TECHNICAL BULLETIN	
	July 1999 TB 1672R
Mfg:	FORD
Model:	WINDSTAR
Liter:	3.8L
V I N:	4
Year:	96-03

Revised Head Bolt Torque Procedure On
1996-03 Ford 3.8L VIN 4 Engines

Bulletin Diagram: Untitled Graphic #2393 for TB 01672R

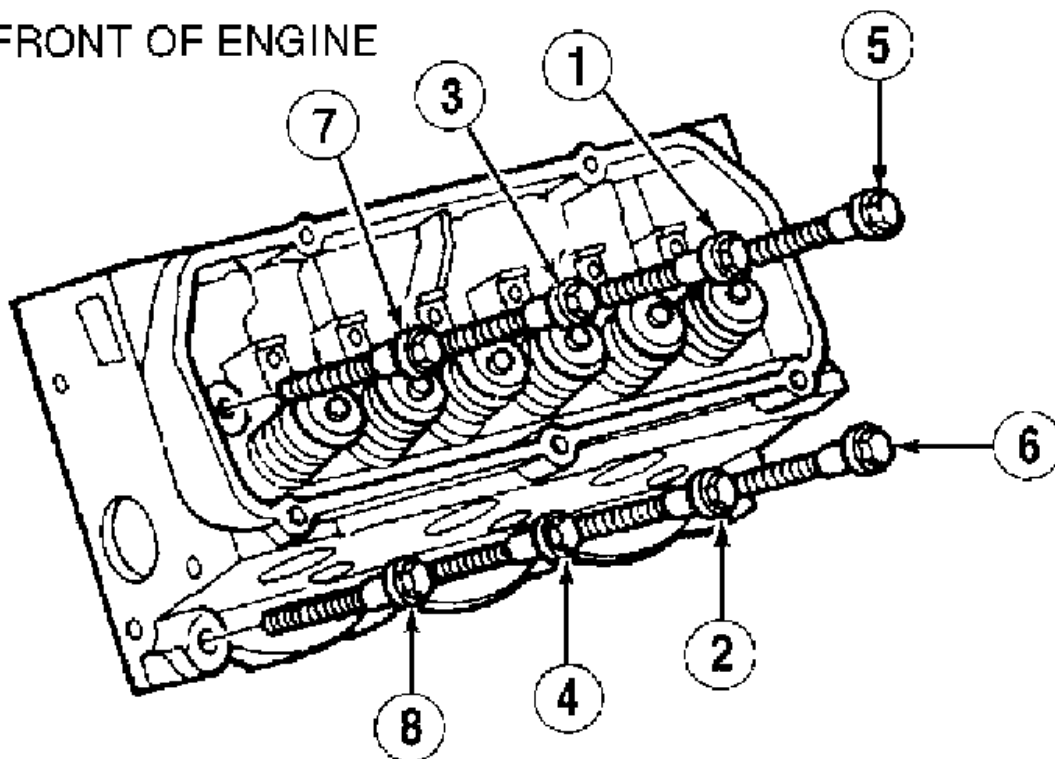
To reduce the likelihood of this condition, Ford now offers a revised head bolt torque procedure. Correctly following the steps listed below and observing the sequence shown in Figure 1 will help in preventing head gasket failures.

Caution: Do not loosen all of the bolts at one time. Work on one bolt at a time in the sequence shown in Figure 1. Failure to loosen bolts in proper sequence could cause the cylinder head to warp. **Note:** This procedure can also be used on

- Step 1) 15 ft/lbs. (20 Nm)
Step 2) 30 ft/lbs. (40 Nm)
Step 3) 37 ft/lbs. (50 Nm)
Step 4) Long bolts: (One Bolt at a time)
a) Loosen long bolt and back out 2 to 3 turns.
b) Retorque long bolt 30-37 ft/lbs (40-50 Nm).
c) Rotate long bolt an additional 175-185° degrees.
d) Go to the next bolt in sequence.

- Short bolts: (One Bolt at a time)
a) Loosen short bolt and back out 2 to 3 turns.
b) Retorque short bolt 15-22 ft/lbs (20-30 Nm).
c) Rotate short bolt an additional 175-185° degrees.
d) Go to the next bolt in sequence.
